Well Name: CANAL 20/19 FED COM	Well Location: T21S / R27E / SEC 20 / NENE / 32.4699353 / -104.2047142	County or Parish/State: EDDY / NM
Well Number: 853H	Type of Well: CONVENTIONAL GAS WELL	Allottee or Tribe Name:
Lease Number: NMNM0354232	Unit or CA Name:	Unit or CA Number:
US Well Number: 3001556355	Operator: MEWBOURNE OIL COMPANY

Notice of Intent

Sundry ID: 2864104

Procedure Description: Mewbourne Oil Company requests that the following changes be made to the Canal 20/19 Fed Com #853H (30-015-56355): • MOC requests to change the name of the Canal 20/19 Fed Com #853H to the Canal 20/19 Fed Com #853Y. • MOC requests to skid the Canal 20/19 Fed Com #853H f/ 1040 FNL & 355 FEL (20) to 940 FNL & 355 FEL (20). • Attached C-102 reflecting name change to Canal 20/19 Fed Com #853Y • Attached Dir Plan/Plot, Drlg Program, & C-102 reflecting requested changes to skid Canal 20/19 Fed Com #853H.

Sundry Request:

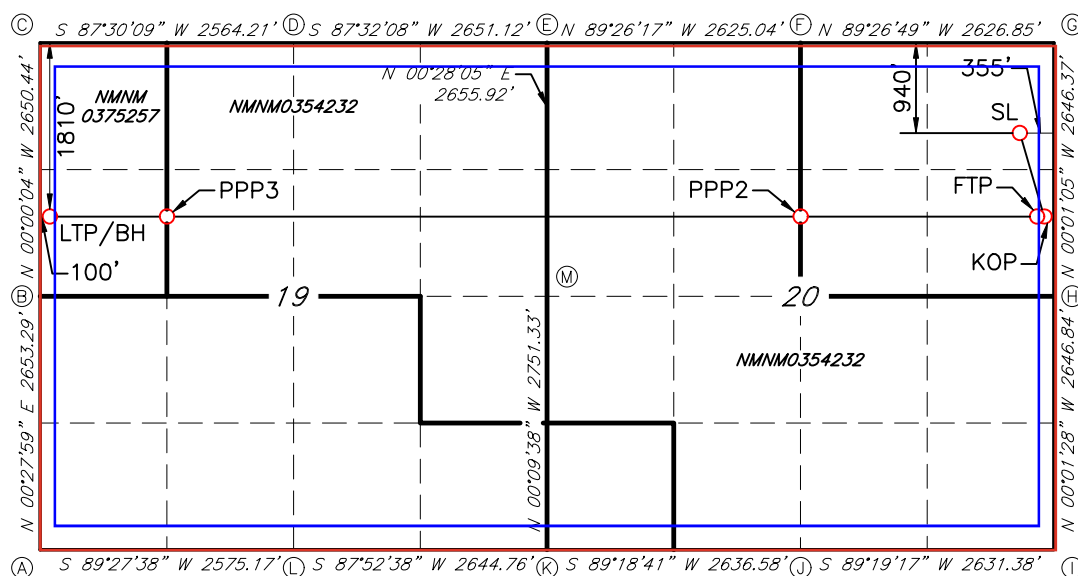
Mewbourne Oil Company requests that the following changes be made to the Canal 20/19 Fed Com #853H (30-015-56355):

- MOC requests to change the name of the Canal 20/19 Fed Com #853H to the Canal 20/19 Fed Com #853Y.
- MOC requests to skid the Canal 20/19 Fed Com #853H f/ 1040 FNL & 355 FEL (20) to 940 FNL & 355 FEL (20).
- Attached C-102 reflecting name change to Canal 20/19 Fed Com #853Y
- Attached Dir Plan/Plot, Drlg Program, & C-102 reflecting requested changes to skid Canal 20/19 Fed Com #853H.
